Reference	SSM72579
Models	Discovery Sport / L550
Title	L550 - Rear Park Aid Inoperative
Category	Electrical
Last modified	15-Feb-2016 00:00:00
Symptom	203000 Basic Electrical
Attachments	Label.pdf (Label.pdf)

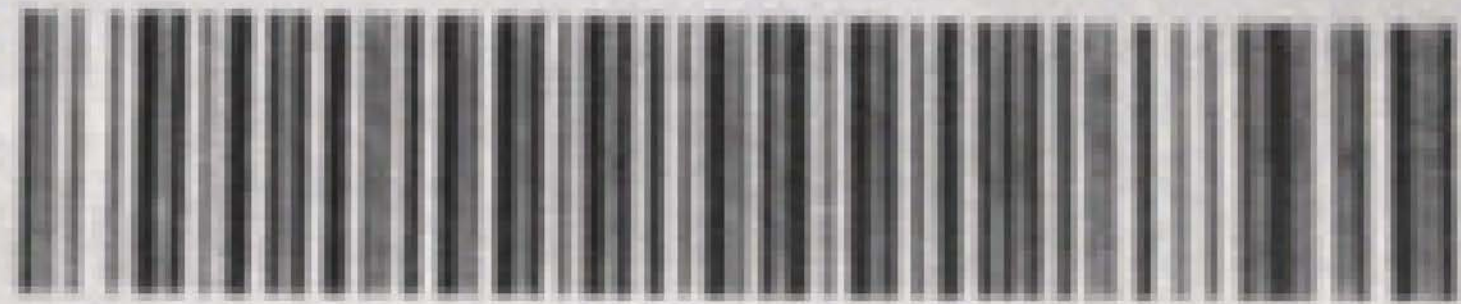
If the fog lamp is damaged, please replace it with the latest level part in MicroCat. Latest level parts can be identified with a green dot on the manufacturer's label. Further more, the production date will be after 20/11/2015. Both of these are highlighted on the picture attached.

Fog lamp service part numbers are as follows:

- LR060910
- LR060911
